**AGENDA
BOARD OF ZONING APPEALS
MAY 16, 2019
LAKEWOOD CITY HALL**

7. Docket No. 05-08-19

17852 Cannon Avenue aka 1297 West Clifton Boulevard

May Board of Zoning Appeals Review

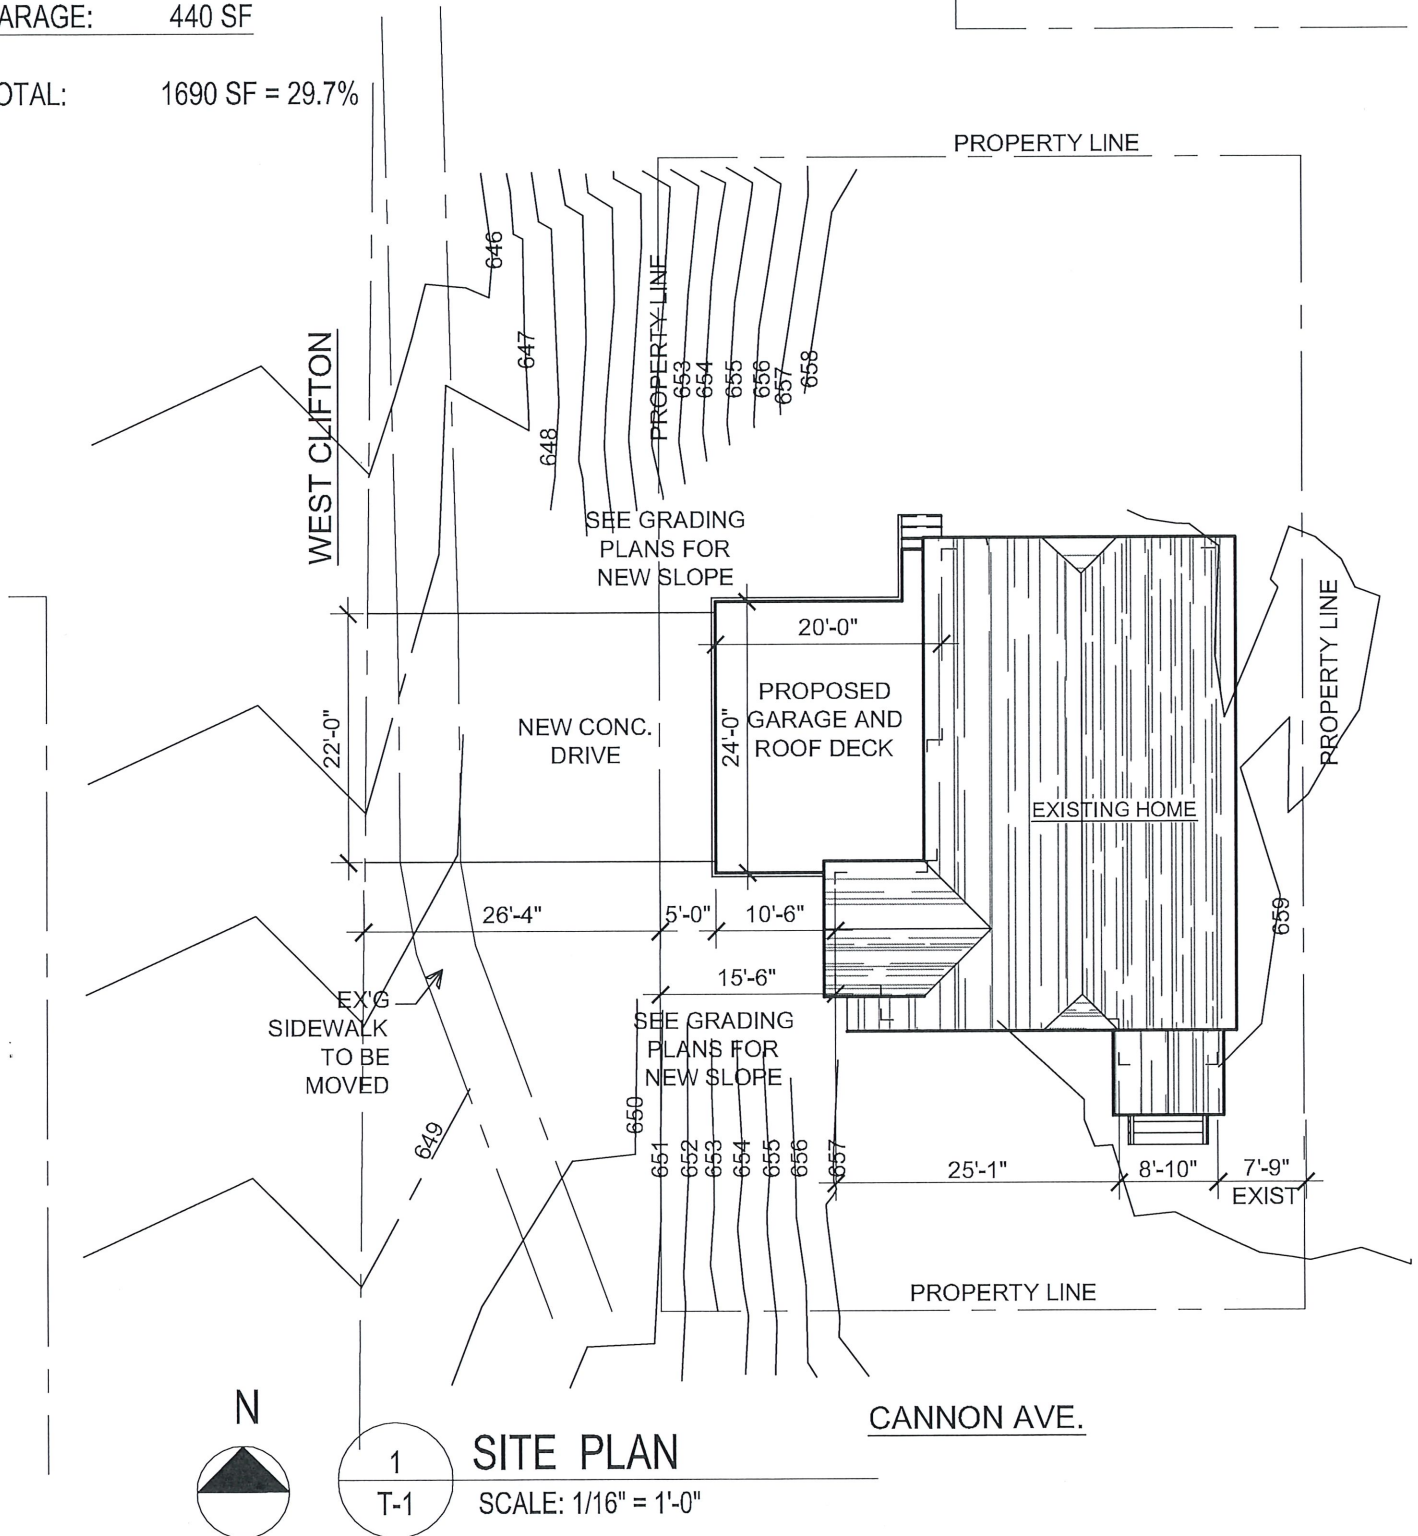
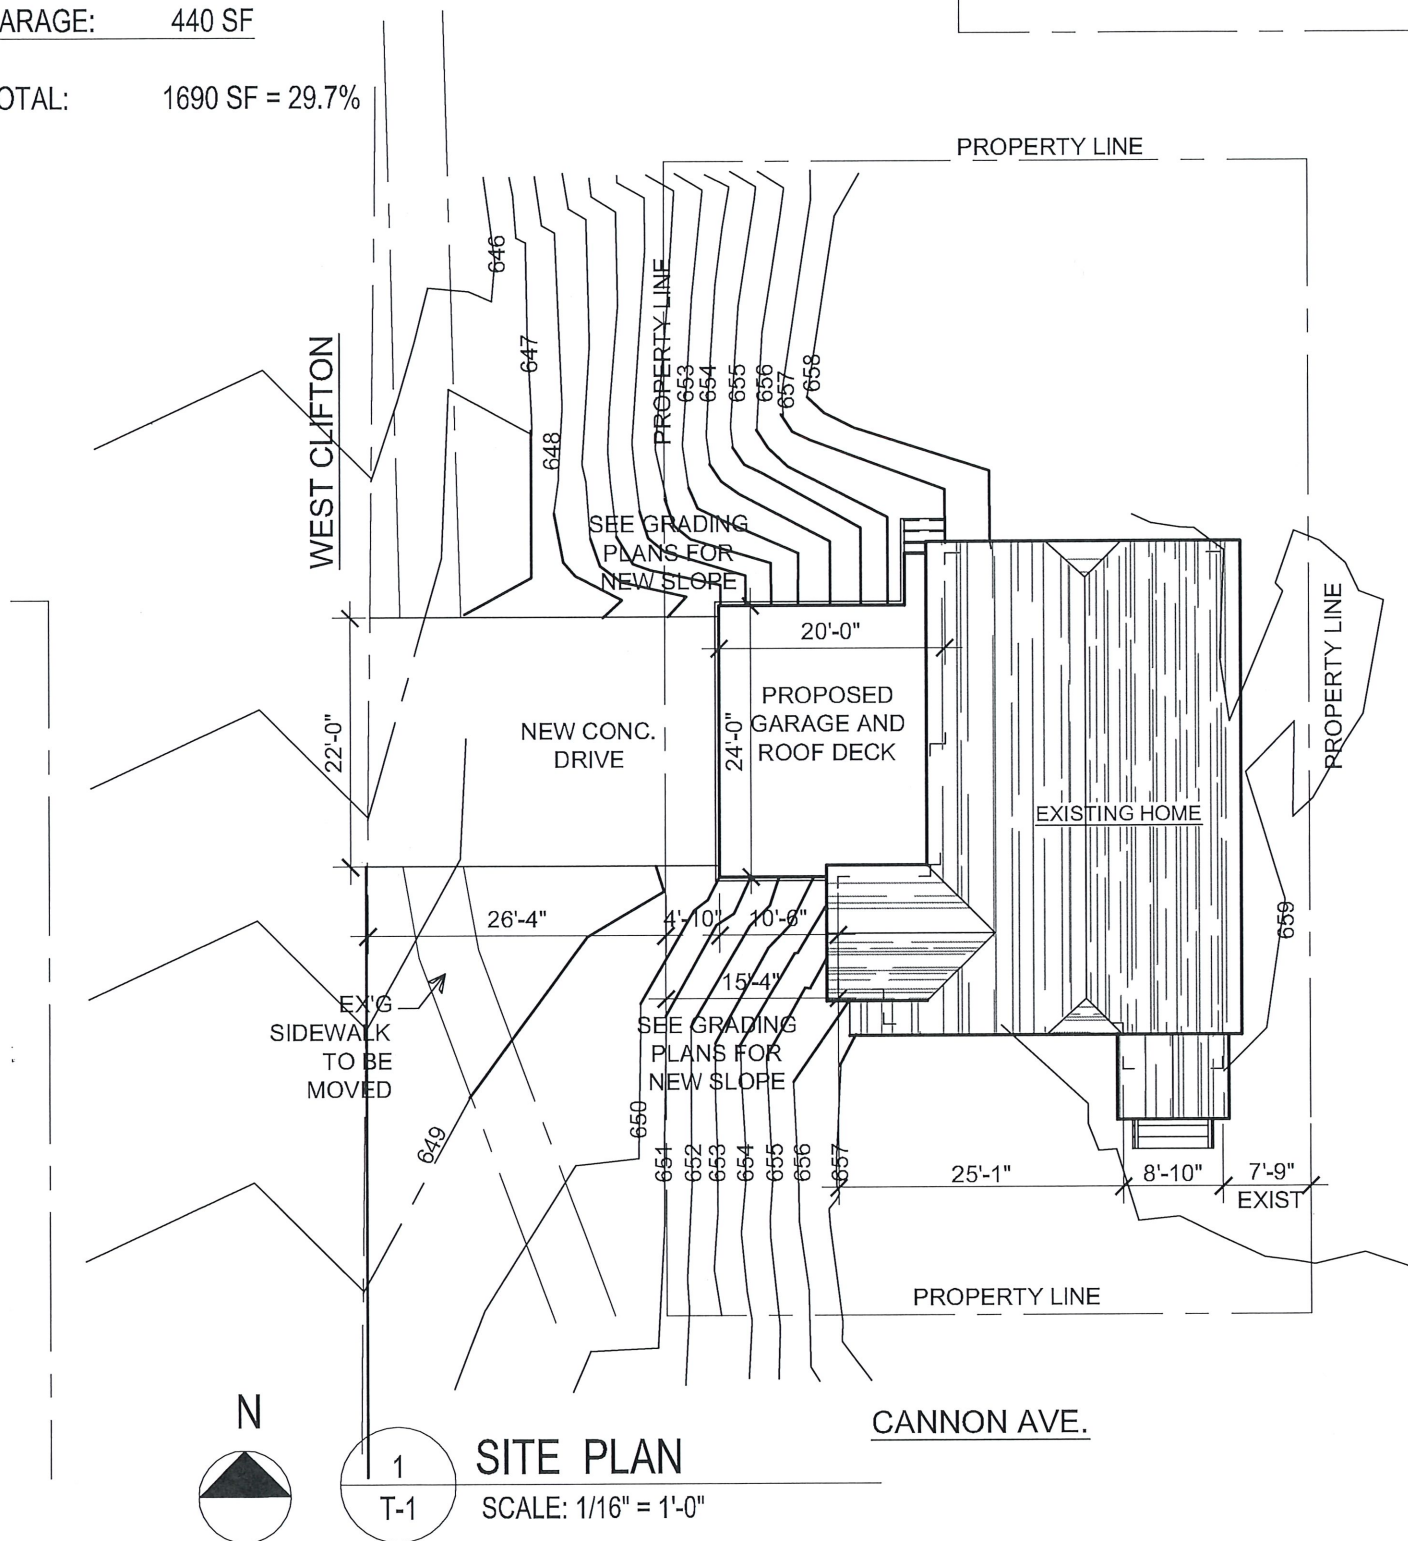
- The two northern runs of 6" PVC storm pipe needs to be connected to the storm sewer main in the right of way. These cannot daylight to the slope or the street.

- Confirm that the sidewalk has the appropriate cross slopes through the driveway and down the hill. It can't follow the slope of the hillside. The plan now shows about 6" and 4" of cross slope in the sidewalk as it goes through the driveway.

- The city sidewalk standard drawing needs to be included on the plans. The City's clean out detail needs to be included in the plans (for the cleanout at the Right of Way). These are on the City's website. Engineering Dept. section

- Dandy Bags are prohibited in the City ROW. Must use ADS flex storm inlet protection.
- Add note: The Contractor shall contact Joe Schaller, PE (Lakewood Engineering Representative) when working in the ROW.

- Add note: The Contractor shall contact Joe Schaller, PE 440.537.8945 (Lakewood Engineering Representative) to observe the Contractor's dye test to confirm that the storm and sanitary laterals are properly connected.

The proposal would attach a garage to the primary structure and increase the primary lot coverage from 25% to 41%. The lot size is 5,822 SF, 25% of the lot is 1455.5 SF. The addition of a garage to the primary structure increases the coverage to 1,690 SF which is 234.5 SF or 16% more than the allowed 25%. Request a variance to exceed primary lot coverage by 16% for a total of 41% lot coverage. ROW work needs to be to the satisfaction of the City Engineer

The proposal would decrease the side yard on the west side of the property to 5'2". The existing side yard on the east side of the building is 7'9" for a combined total of 12'9". The minimum side yards allowed are 5 FT on each side and the total must be no less than 15 FT. Request a variance to reduce the minimum sum of both combined side yards to 12'9". ROW work needs to be to the satisfaction of the City Engineer

Include an approval stating that the ROW work needs to be to the satisfaction of the City Engineer
